Errata Document

A. This document details the limitations of the cascading option of the AD73360 due to a bug in the current silicon.

Figure 2. Cascade Timing for a Three-Device Cascade

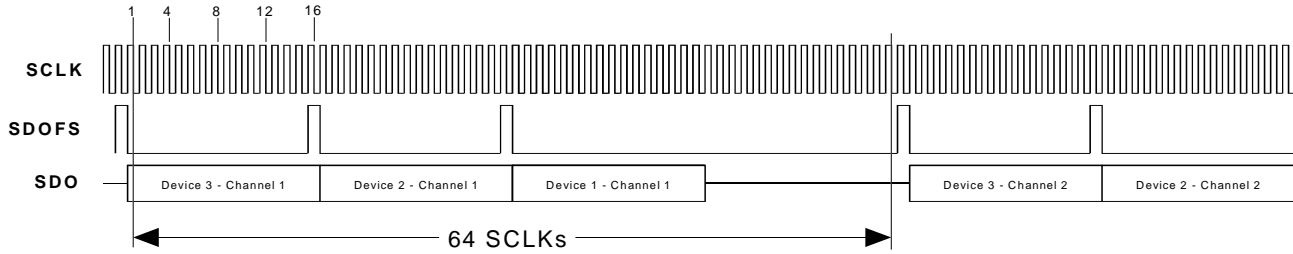
For cascades of more than two devices the AD73360 will leave too many SCLKs between transmitting channel information. This increases the time it takes to transmit the ADC data and since a DSP or microcontroller must read data from all the ADCs in the cascade in one sample period the number of devices which can be cascaded will be limited. Figure 2 shows the effect the additional SCLKs have on a cascade of three devices.

For a cascade of a given length, the SCLK rate and Sample Period will determine if the cascade can be used successfully. A low sample rate will allow more time for the ADC data to be read. Similarly a high SCLK rate will transmit the data in a shorter time. Since both the SCLK rate and Sample Rate are derived from the same DMCLK the number of combinations is limited. As most applications will require a predetermined sample rate, the SCLK speed will be the limiting factor in the cascade length that can be used. Table I shows the maximum cascade length for a given SCLK and Sample Rate. The table assumes that a MCLK of 16.384MHz is used.
